ORIGINATION FORM

Proposed Revisions to a Standard Plans Index
(Please provide all information — Incomplete forms will be returned)

Index Number: 430-030
Sheet Number (s): 1 and 3 of 4
Index Title: Straight Concrete Endwalls Single and Multiple Pipe

Summary of the changes:

=====**STRAIGHT CONCRETE ENDWALL**=====

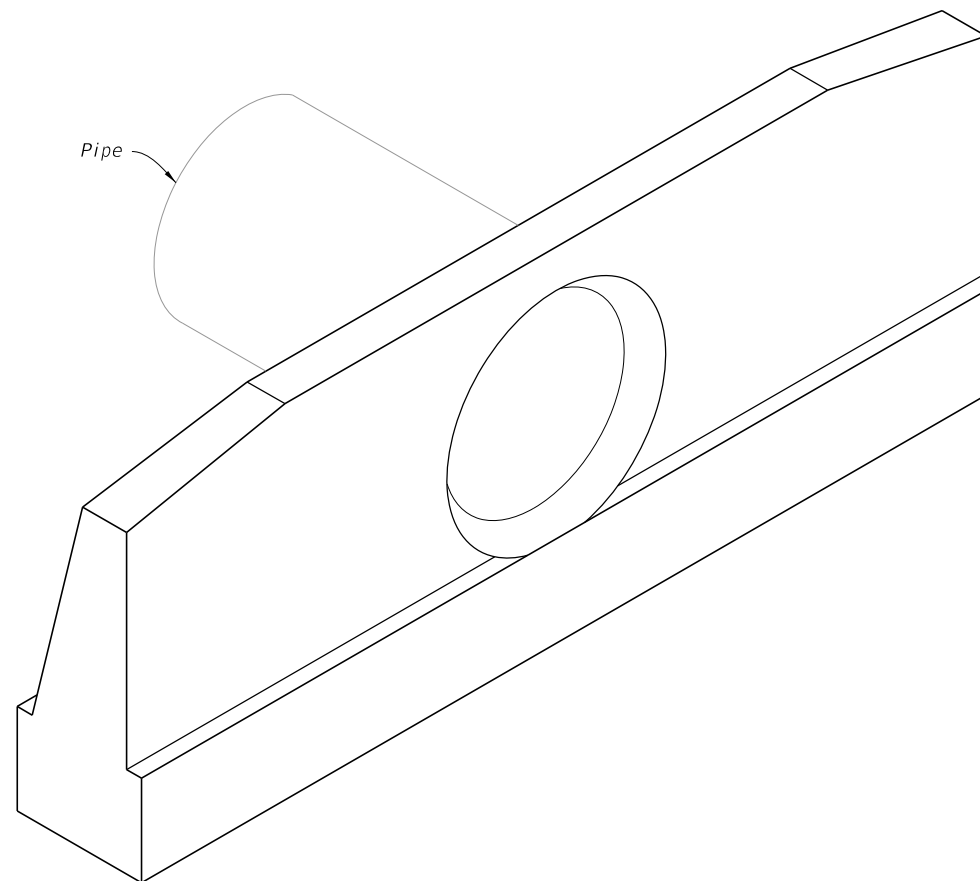
Sheet 1: Changed GENERAL NOTE 1 from "Class I" to "Class II".
Sheet 3: Changed "Class I" to "Class II" in both of the Tables.

Changed to reflect Materials specification change that removes the designation for Class I Concrete.
Please see the attached Standard Specification Section 346 DRAFT for the Class I revisions proposed by the State Materials Office.

CHANGED TO: Class II

1. Use ~~Class I~~ concrete.
2. ~~Reinforcing steel is~~ either Grade 40 or 60.
3. Endwalls may be cast in place or precast concrete. (Additional reinforcement necessary for handling precast units will be determined by the Contractor or the supplier).
4. Chamfer all exposed edges and corners to $\frac{3}{4}$ ".
5. Endwall dimensions, locations and positions are for round and elliptical concrete pipe and for round and pipe-arch corrugated metal pipe. Round concrete pipe shown.
6. On outfall ditches with side slopes flatter than 1:1.5 provide 20' transitions from the endwall to the flatter side slopes, right of way permitting.
7. Construct front slope and ditch transitions in accordance with Index 430-001.
8. Quantities shown are for estimating purposes only.

STRAIGHT CONCRETE ENDWALL

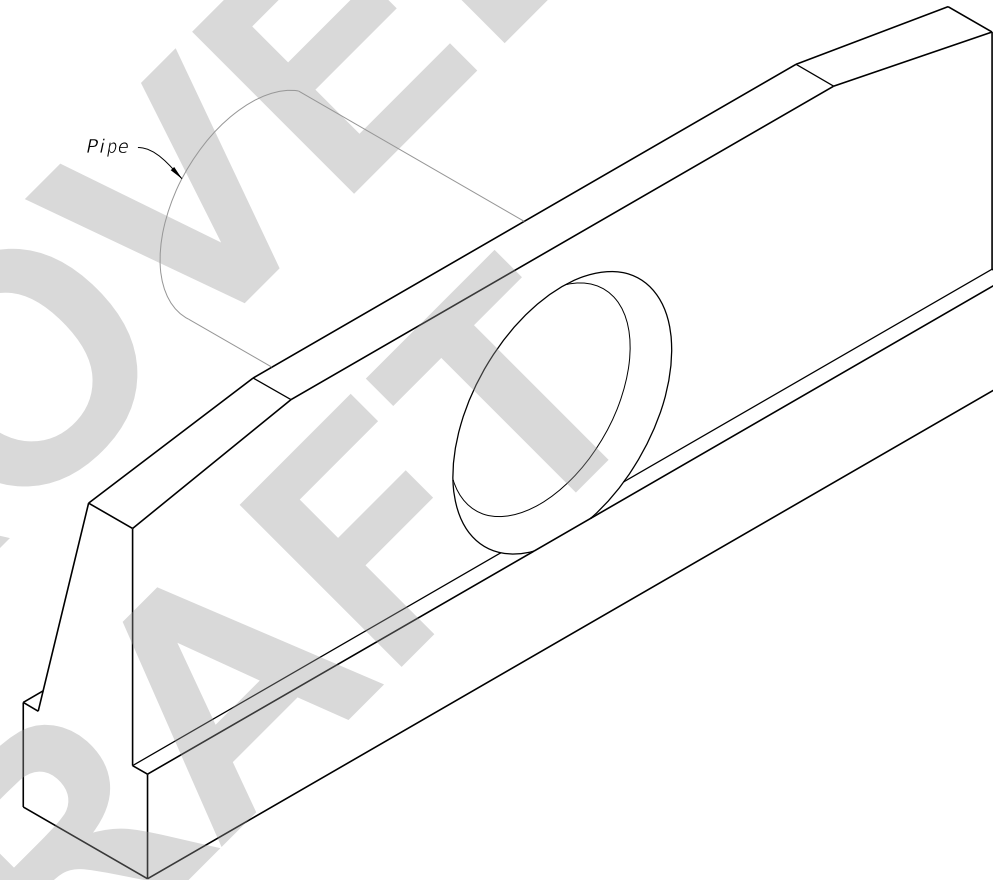
1. Use Class II concrete.
2. Reinforcing steel is either Grade 40 or 60.
3. Endwalls may be cast in place or precast concrete. (Additional reinforcement necessary for handling precast units will be determined by the Contractor or the supplier).
4. Chamfer all exposed edges and corners to $\frac{3}{4}$ ".
5. Endwall dimensions, locations and positions are for round and elliptical concrete pipe and for round and pipe-arch corrugated metal pipe. Round concrete pipe shown.
6. On outfall ditches with side slopes flatter than 1:1.5 provide 20' transitions from the endwall to the flatter side slopes, right of way permitting.
7. Construct front slope and ditch transitions in accordance with Index 430-001.
8. Quantities shown are for estimating purposes only.
